Economic Commission for Europe**Inland Transport Committee****World Forum for Harmonization of Vehicle Regulations****Working Party on Lighting and Light-Signalling****Eighty-ninth session**

UN Regulation No. 10 (Electromagnetic Compatibility)**Proposal for a new 07 series of amendments to UN Regulation No. 10 (Electromagnetic compatibility)****Submitted by the expert from by the Informal Working Group on Electromagnetic Compatibility***

The text reproduced below was prepared by the experts from the Informal Working Group on Electromagnetic Compatibility (IWG EMC), with the aim to develop a new 07 series of amendments to UN Regulation No.10. The proposed modifications to the current text of the UN Regulation are marked in bold for new or strikethrough for deleted characters.

"Figure 1

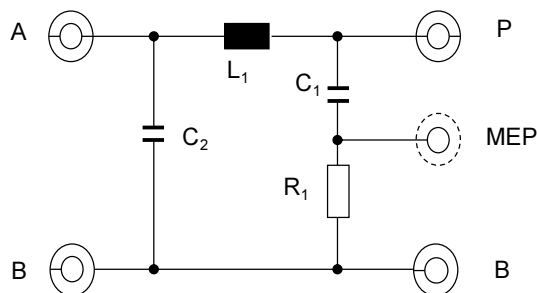
Paragraph 1., figure 1, amend to read:

"Figure 3

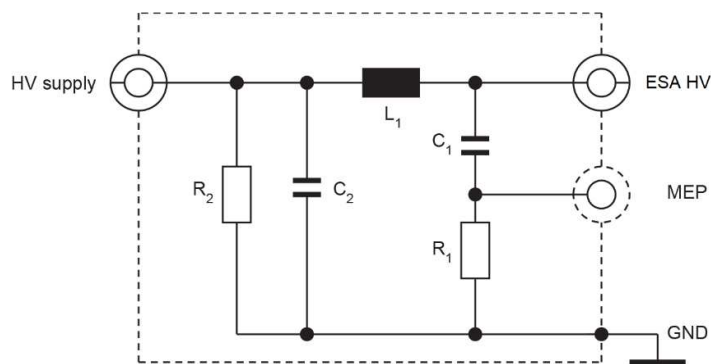
Paragraph 2., figures 3, 4 and 5, amend to read:

"Figure 4

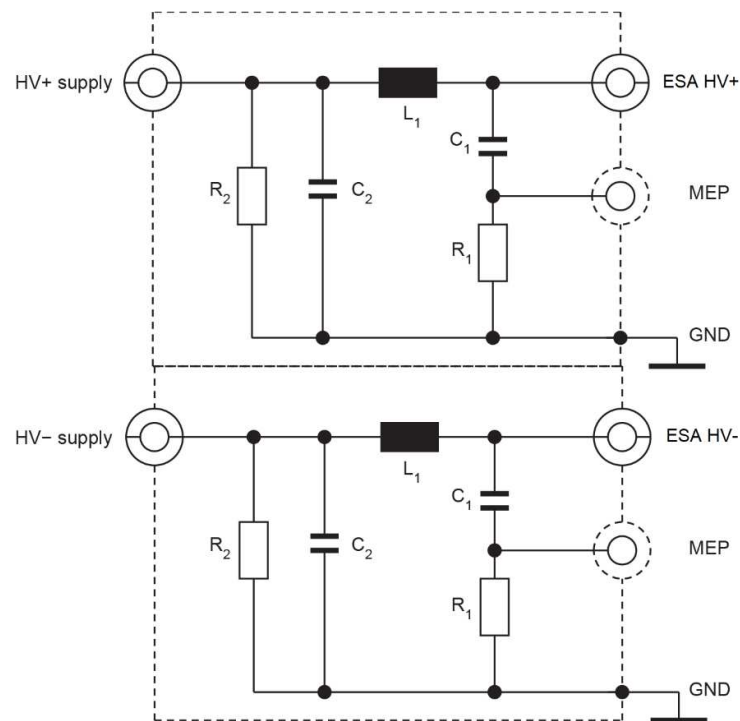
If unshielded HV ANs are used in a single shielded box, then there shall be an inner shield between the HV ANs as described in Figure 4."

Figure 1
Charging mode configuration for Annex 4

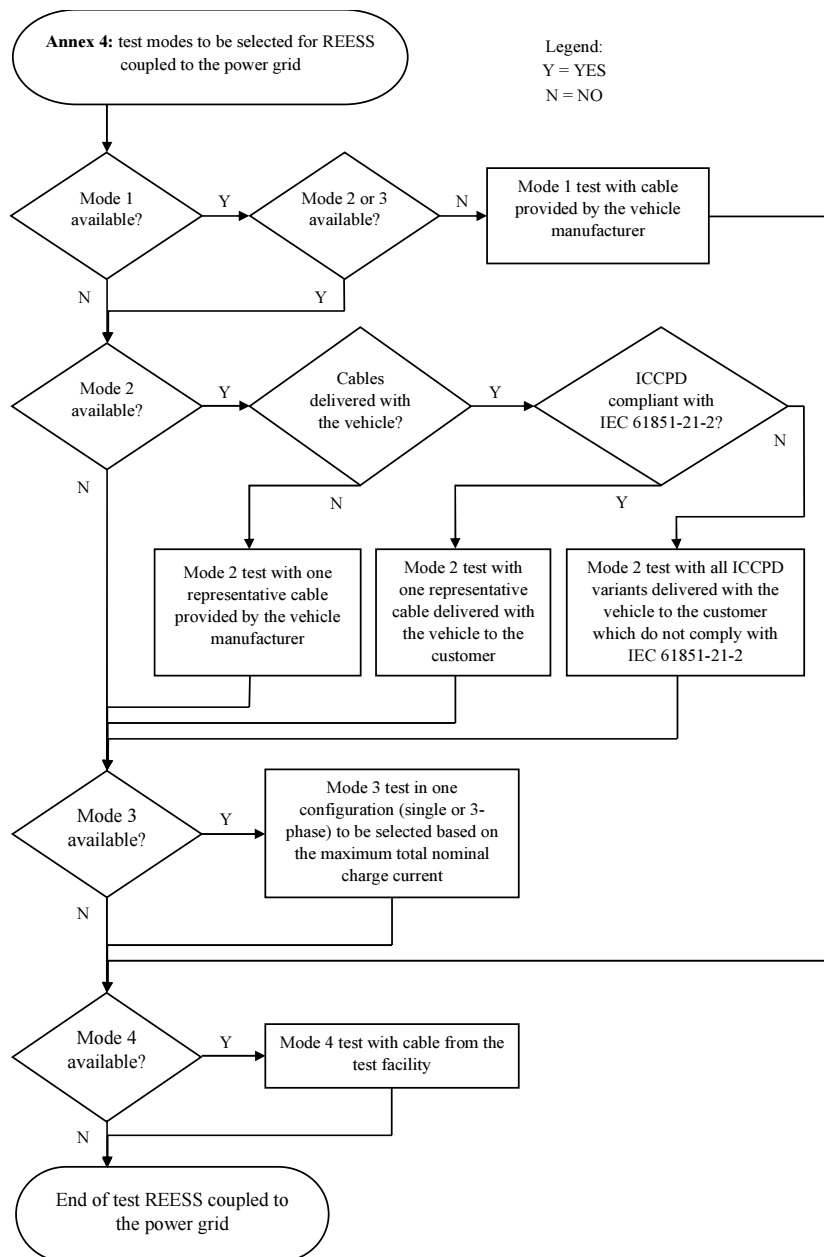
The vehicle shall be tested in the charging mode configuration (if available on vehicle) as defined in flowchart of figure 1

Figure 1

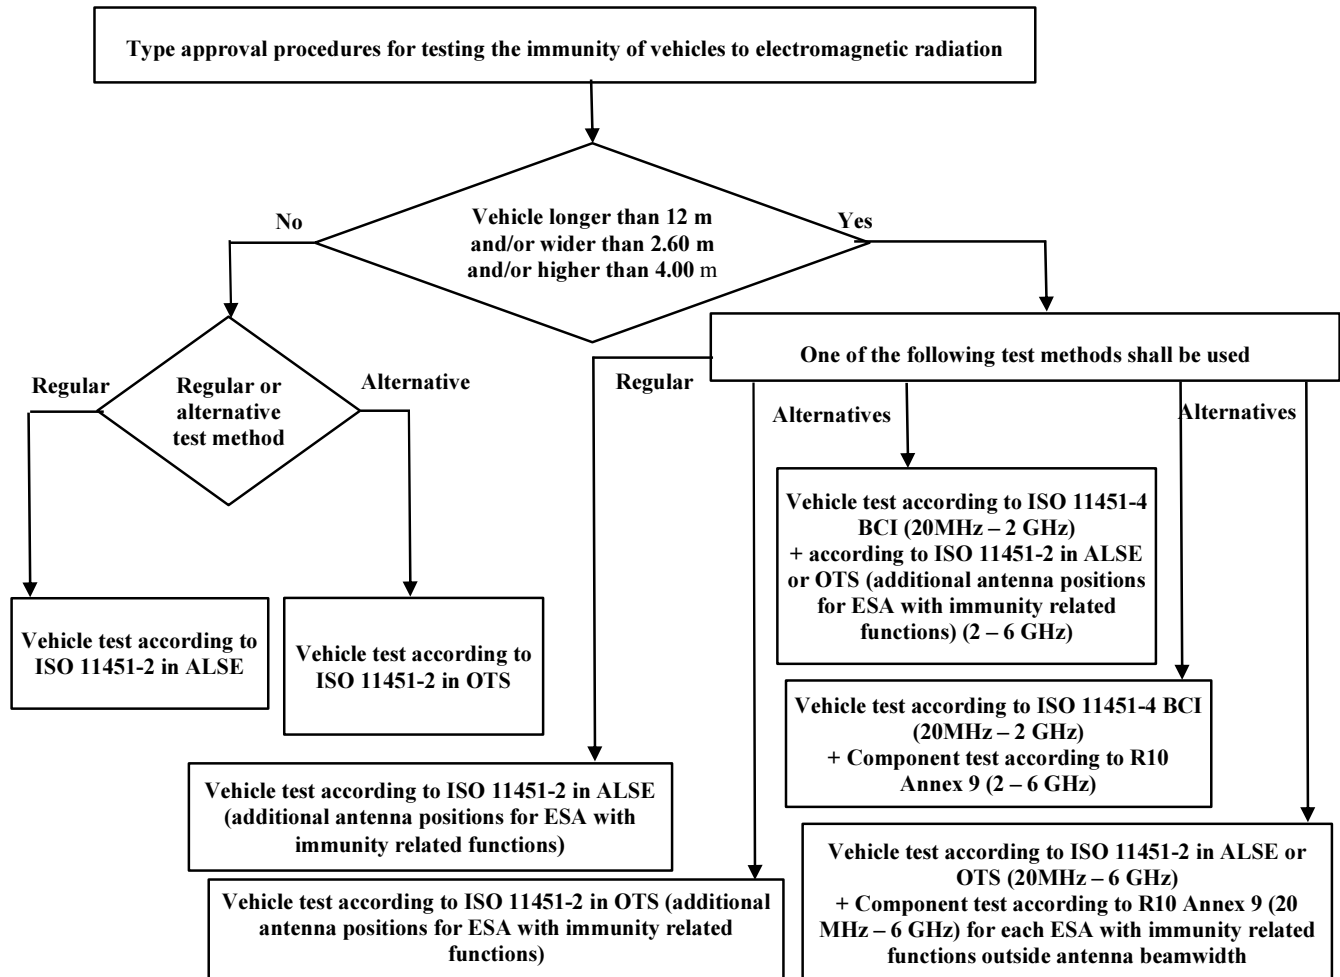
Insert a new paragraph 1.4., to read:

Figure 2
Charging mode configuration for Annex 6"

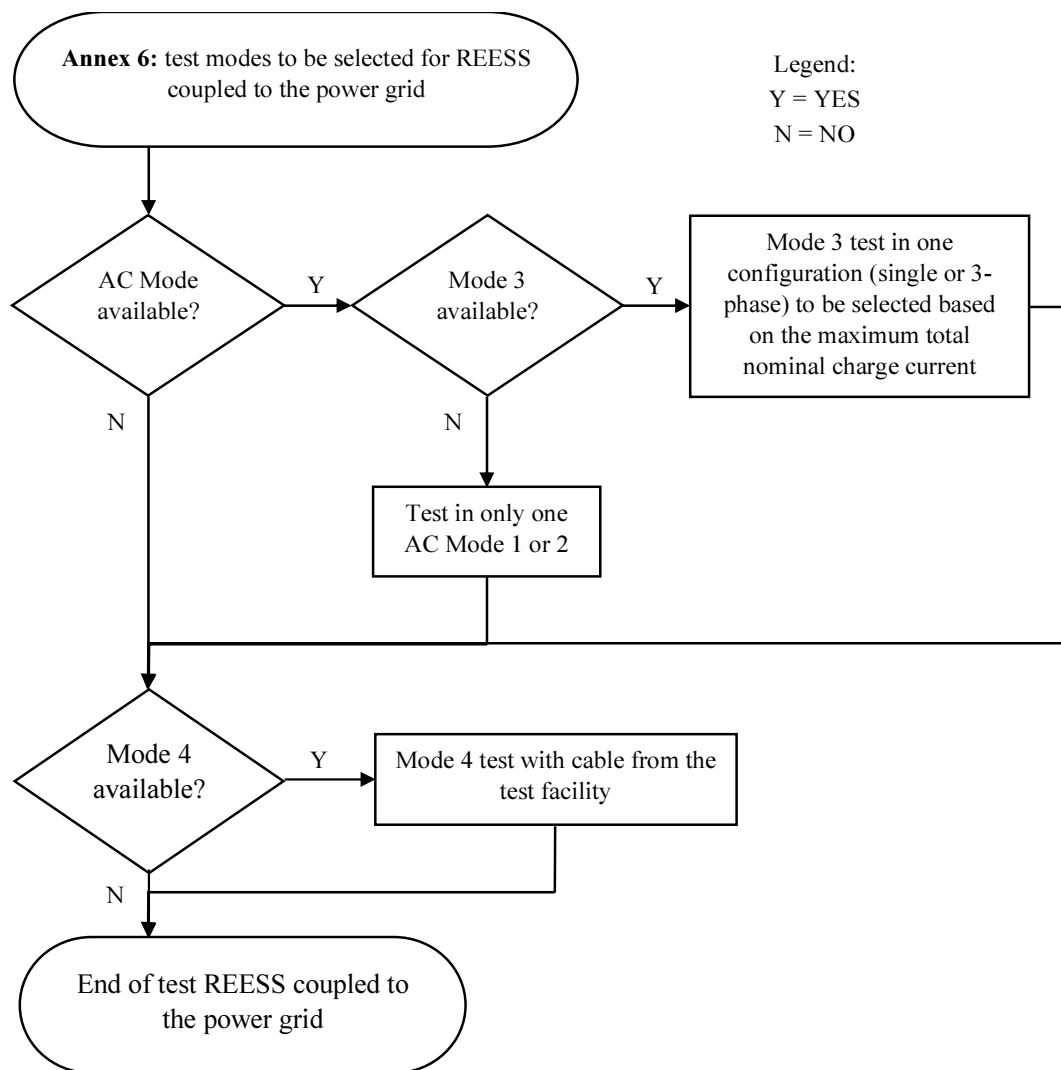
The vehicle shall be tested in the charging mode configuration (if available on vehicle) as defined in flowchart of figure 2

Figure 1
Charging mode configuration for Annex 11]

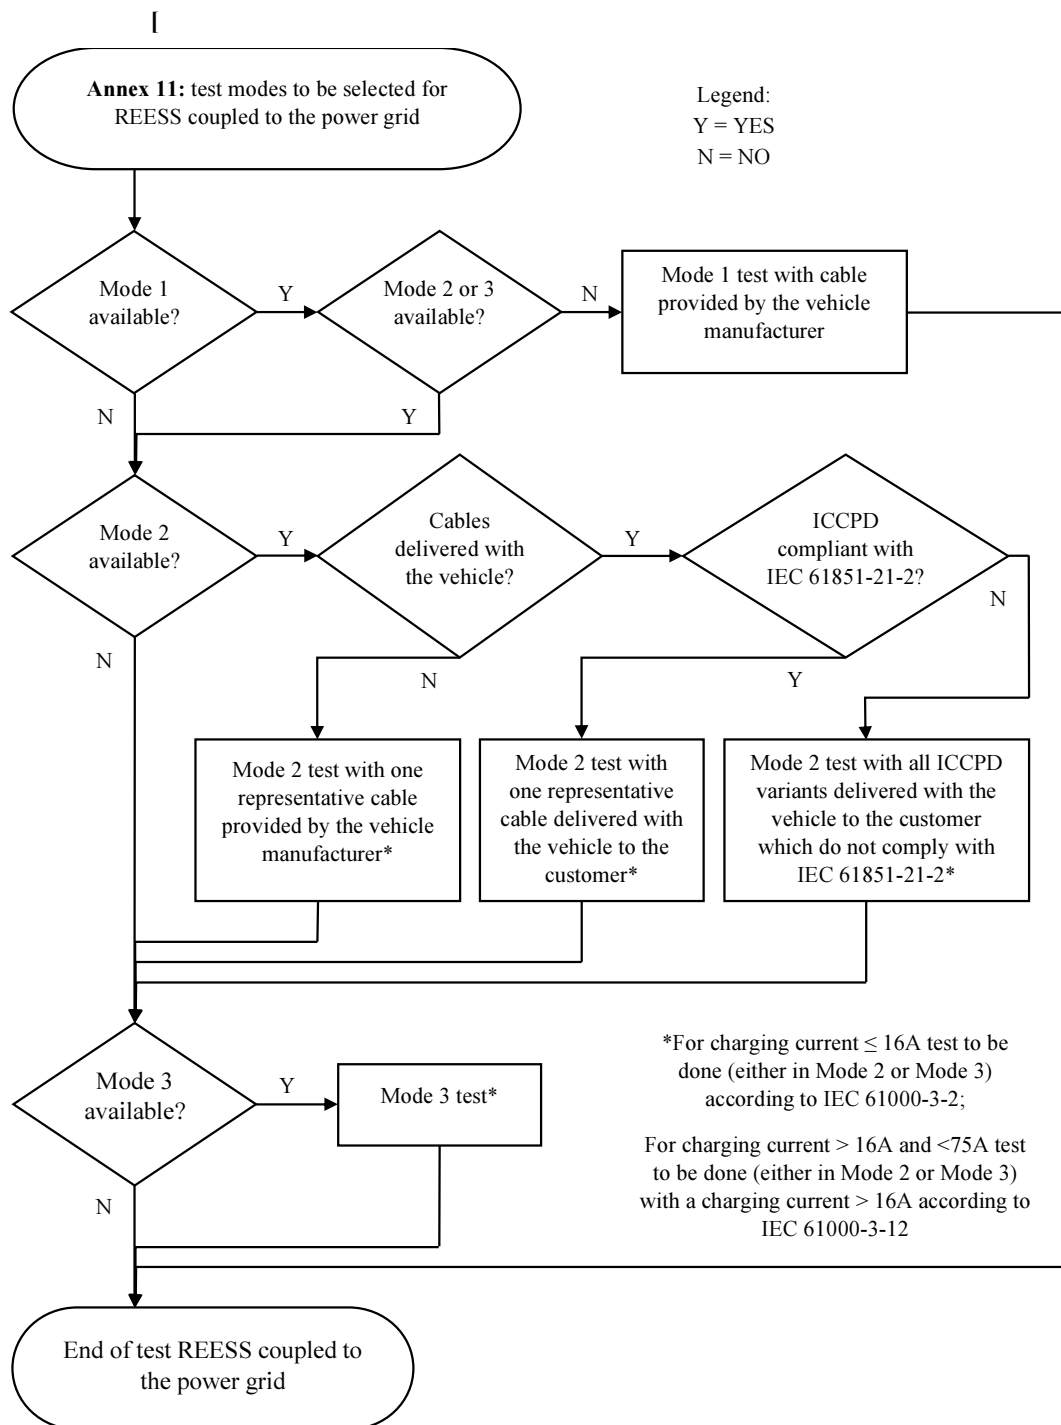
The vehicle shall be tested in the charging mode configuration (if available on vehicle) as defined in flowchart of figure 1

"Figure 1b

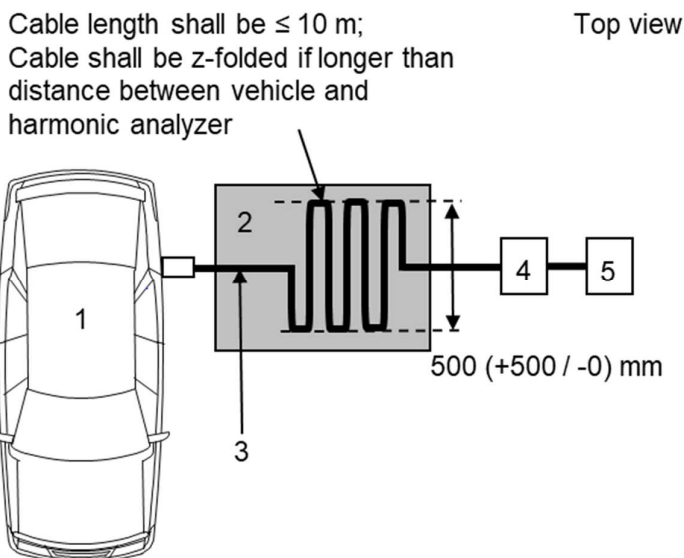
Figure 1b, amend to read:

"Figure 1d

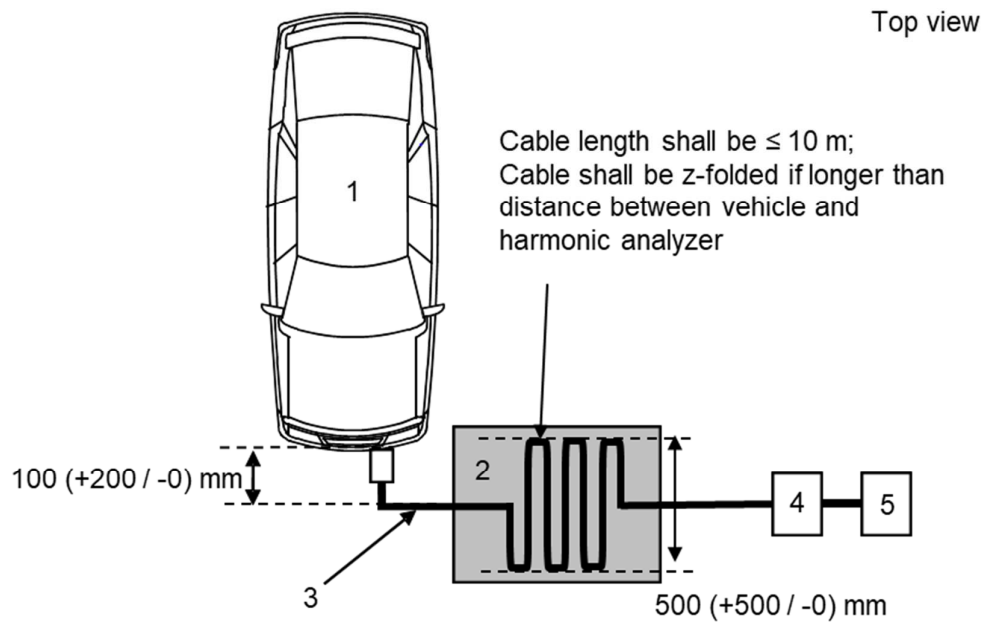
Figure 1d, amend to read:

Figure 1
Charging mode configuration for Annex 12]

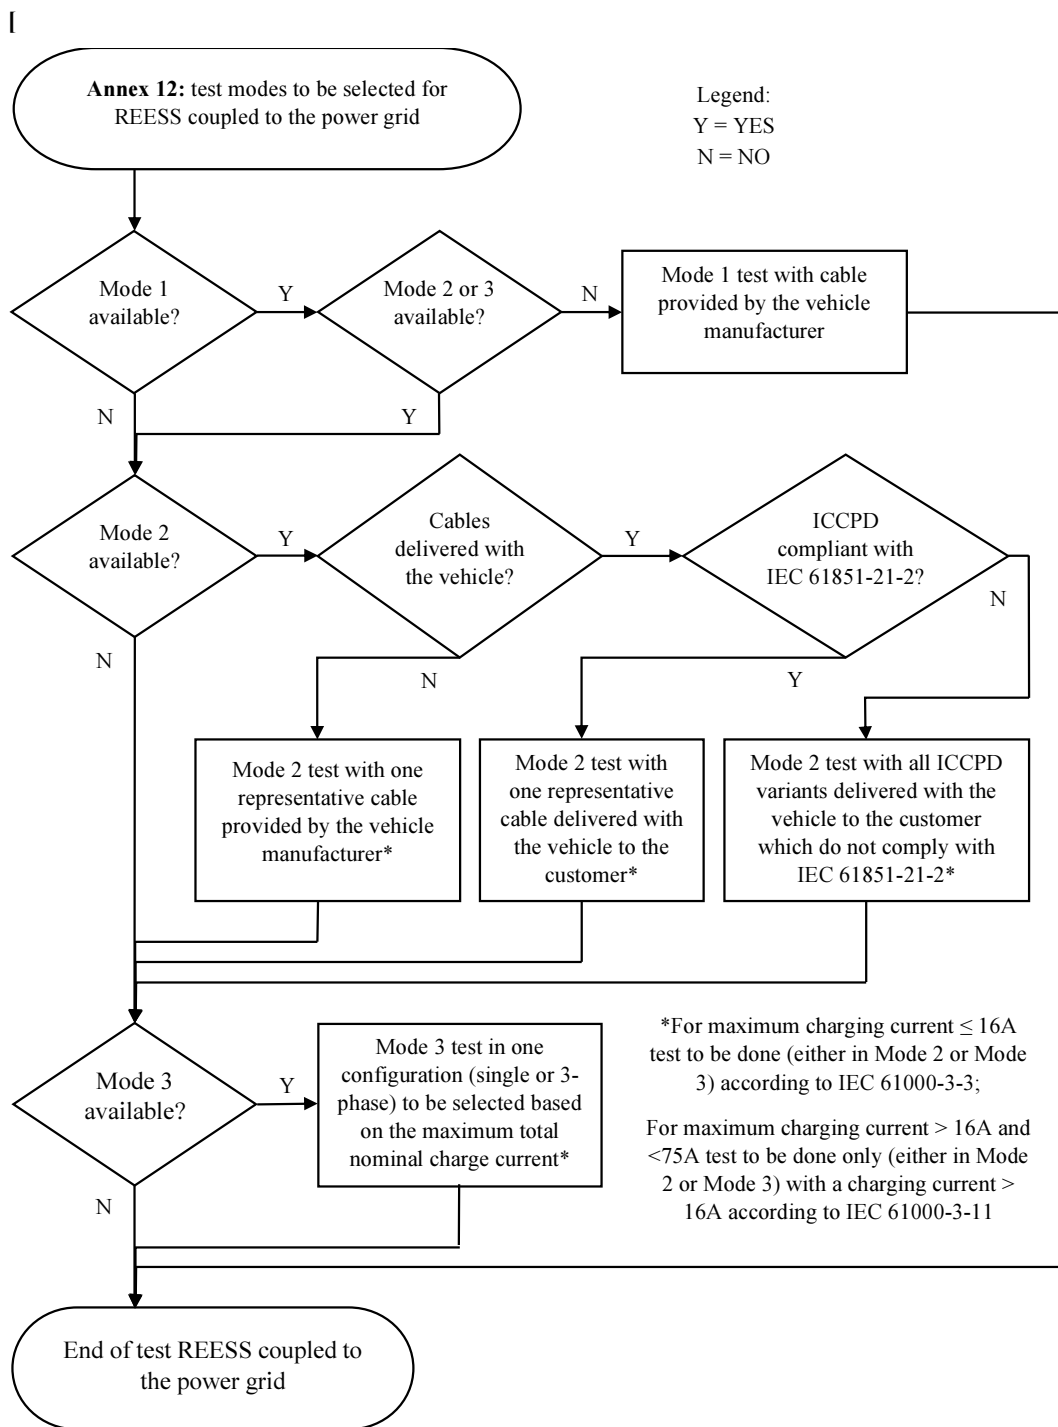
The vehicle shall be tested in the charging mode configuration (if available on vehicle) as defined in flowchart of figure 1

"Figure 1b

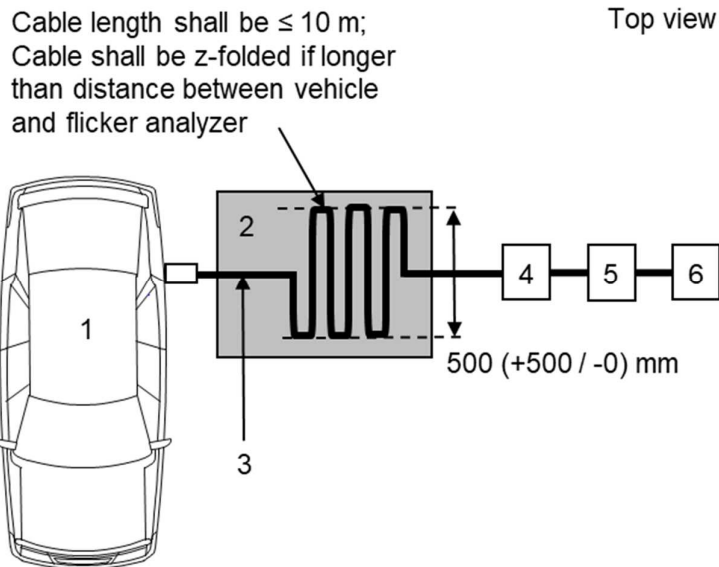
Figure 1b, amend to read:

Figure 1: Charging mode configuration for Annex 13]

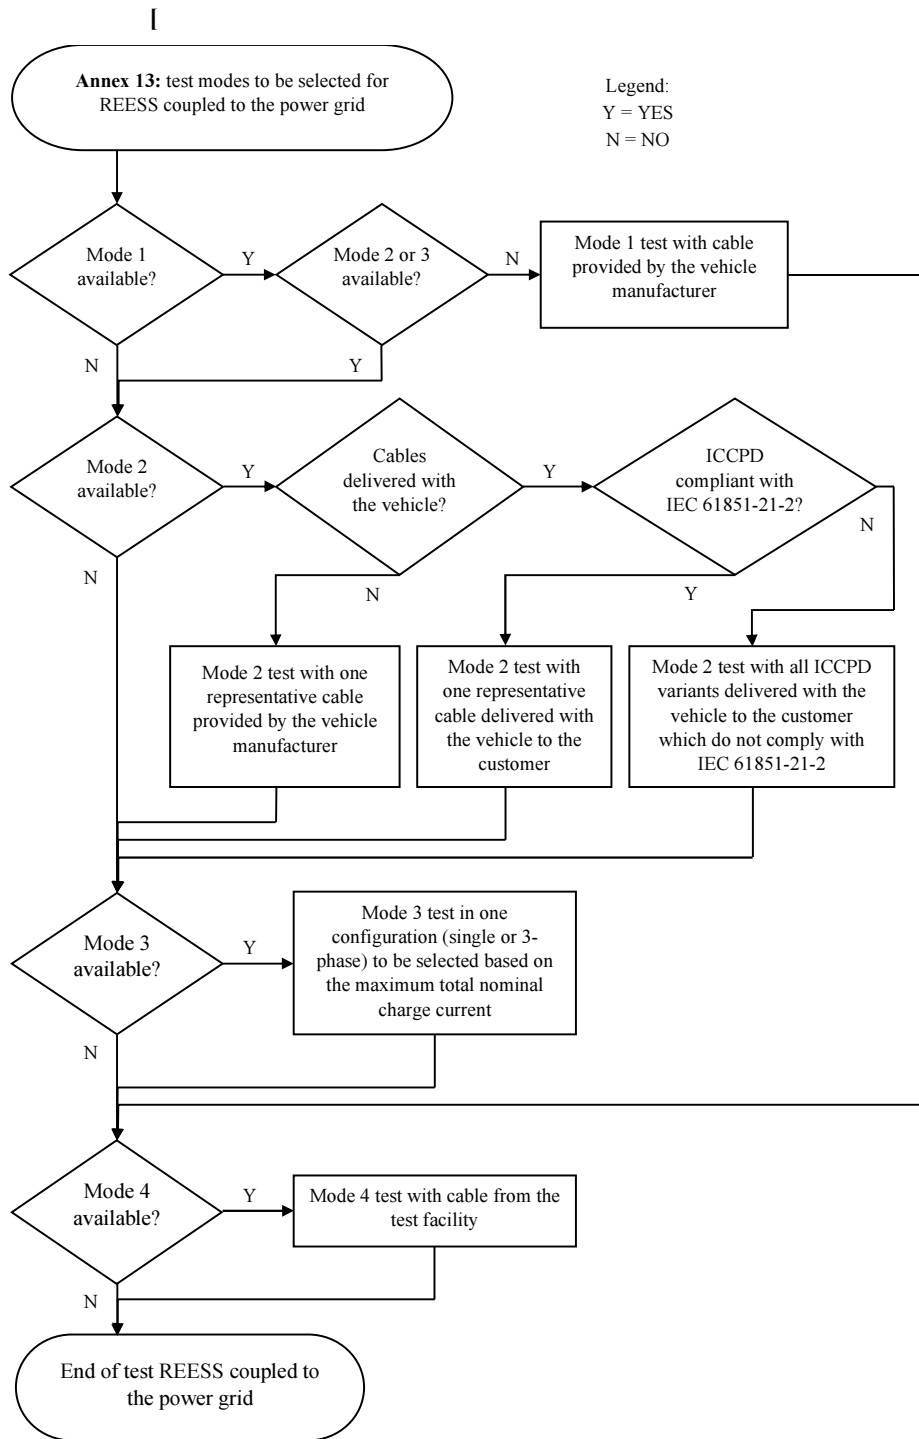
The vehicle shall be tested in the charging mode configuration (if available on vehicle) as defined in flowchart of figure 1

"Figure1b

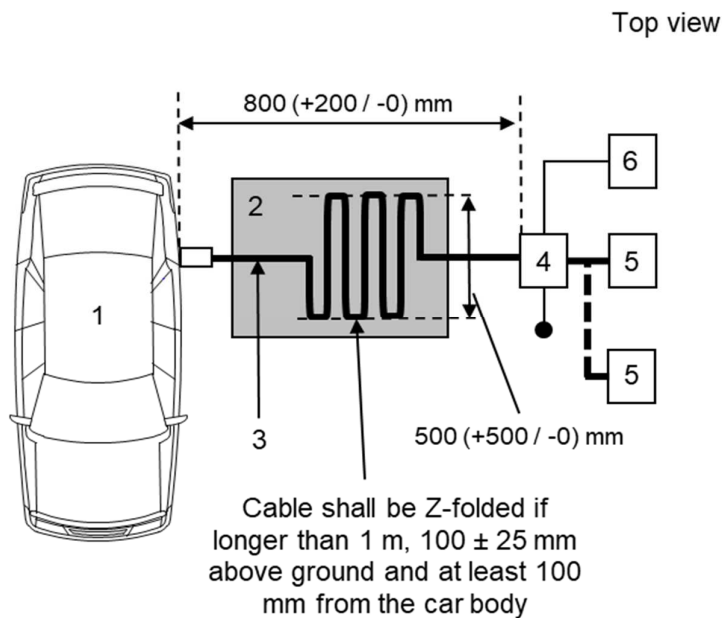
Figure 1b, amend to read:
